LBNF/DUNE Cryogenics

LBNC Review

18-21 February 2018

Agenda item 2 – Highlights 2/2

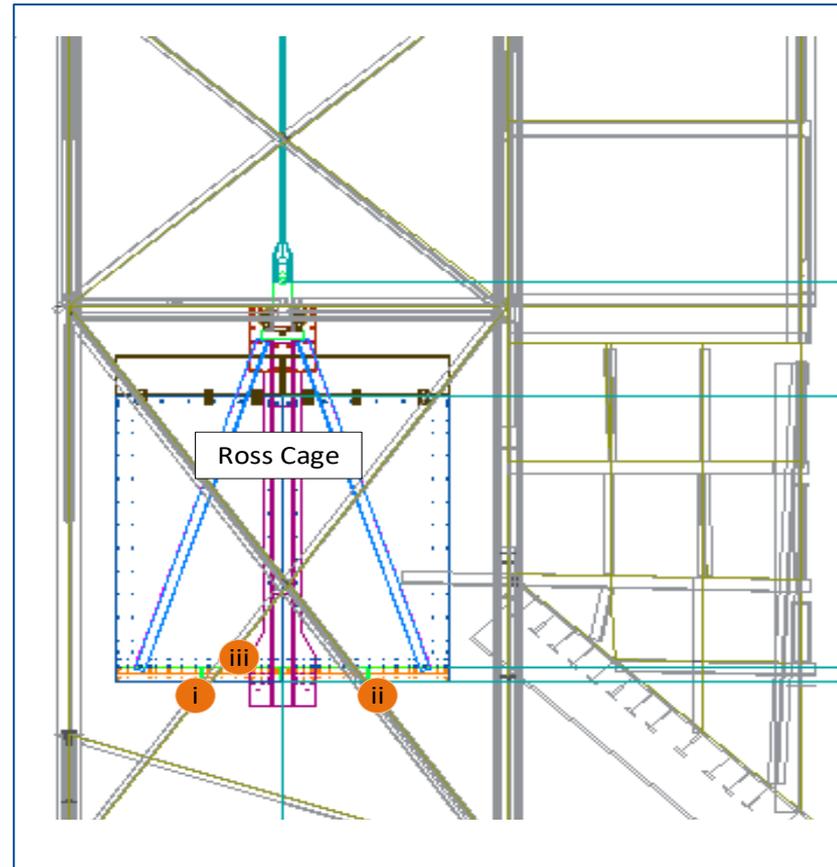
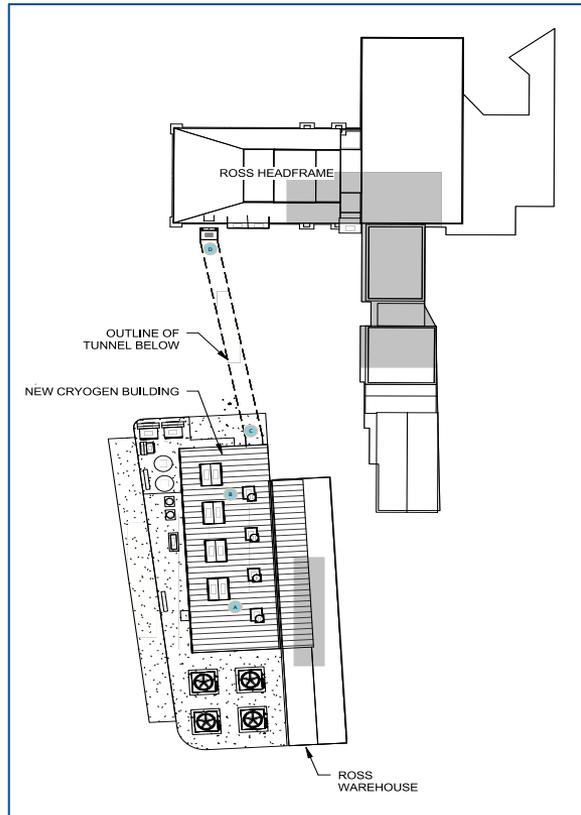
- **Q:** Provide a plan for testing of cryogenics during the commissioning of ProtoDUNE as previously recommended.
- **A:** *Quality Plan from Demaco (manufacturer of the Proximity Cryogenics):* <https://edms.cern.ch/document/1900702/1>. Highlights in next slides.
- **Specs:**
 - EN13445 & EN13480.
 - PED (2014/68/EU).
 - Design P: 10 bara.
 - Design T: 77-300 K (all cryo but regen) and 500 K (regen).
- **Additional testing:**
 - Warm piping testing (Pressure test + He leak check).
 - Controls test.
 - Synchronization.

- Testing during Installation (at CERN):
 - Incoming inspection.
 - Hydraulic continuity.
 - Vacuum.
- On Site Acceptance Test (Warm Acceptance Test):
 - Purge & Flush system.
 - Pressure Test.
 - Helium leak check.
- On Site Acceptance Test (Cold Acceptance Test):
 - All interfaces installed and ready.
 - Cold test with LN2.
 - Helium leak check.
